CABINET MEMBER FOR ENVIRONMENT – 19 DECEMBER 2019

BURFORD – PRIORY LANE: PROPOSED AMENDED WAITING RESTRICTIONS AND PARKING PLACES

Report by Interim Director for Community Operations

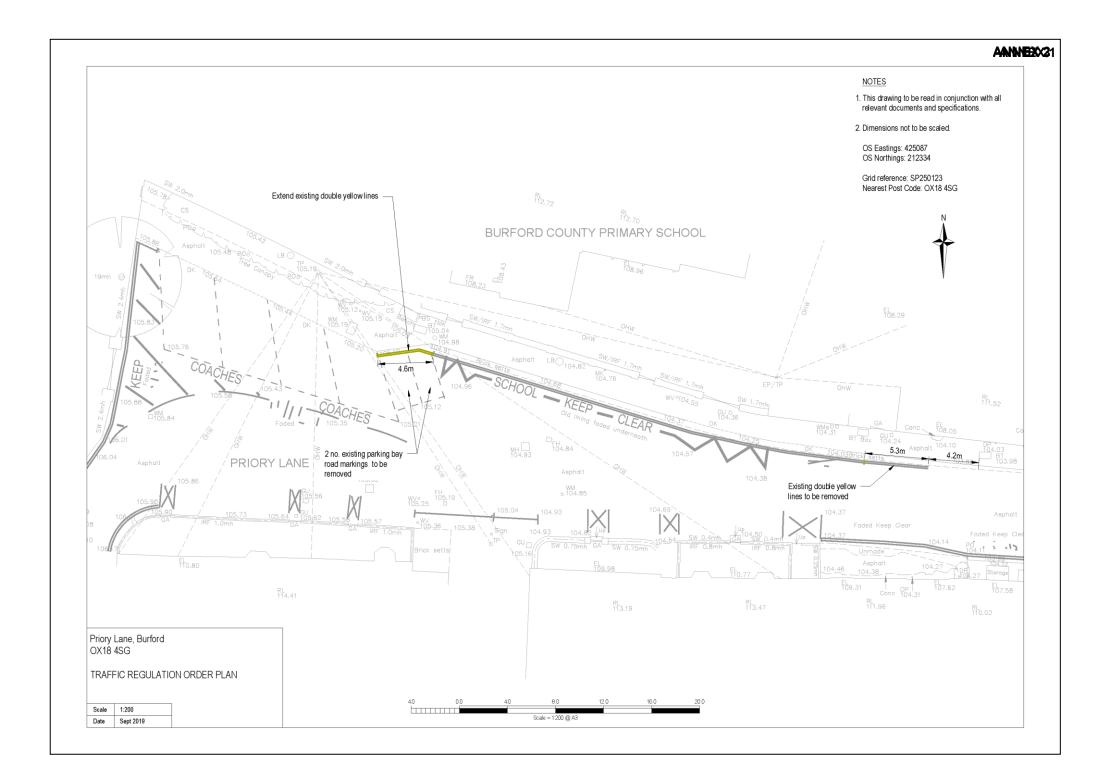
4. The above proposals as shown at Annex 1 have been put forward as a result of approved changes to vehicle access to adjacent land and comprise the removal of two car parking places adjacent to the existing coach parking and the removal of a length of double yellow line to provide an additional car parking space to the east of the access to the primary school.

(2) Burford Town Council	Object – We strongly object to your proposal regarding the above. The loss of two car parking spaces when we are fighting to increase the Town's car parking capacity is not acceptable. The addition of one parallel, small car space in substitution for two 'nose in' spaces both capable of taking 4 x 4s is too high a price to pay.

3. The proposed new space is 4.2m whereas the current space is 4.65m - we are losing car parking space as the current spaces allow cars to park at right angles to the pavement. The new proposed space outside number 12 the car will have to park Parallel. There is also concern from the owner of the garage next to number 12 that it will make it very difficult to get in and out of their garage. If there was an application to build a garage next to number 12, with the new space being placed there, I very much doubt it would be allowed to be built so close to the end of a double yellow line.

(8) Local Resident, (Burford)	Object – oppose the changing of the DYLs in priory on the grounds of the loss of a parking space in the move. It is very clear currently we have two spaces and under the proposal we are going to be left with one actually a smaller

than normal parking space.
	Corresponding length - Whoever has decided that a corresponding length will be provided has failed to see the current spaces work in right angle to the pavement and the proposed is parallel, so we are losing a space. Burford needs all the park spaces it has and more. I cannot see the benefit to Burford in the proposed move.

- In response to the above, it is accepted that the proposal does result in the loss of one car parking space but it should also be noted that the revised provision at 5.3 metres in length should be adequate for most cars and that vehicles parking here in accordance with the Highway Code would not present a difficultly for users of the adjacent garages.

- The proposed new vehicle access for The Old Rectory is not considered to present a significant risk to pedestrians, noting that there are other vehicle accesses in the road which are not the source of any concern.
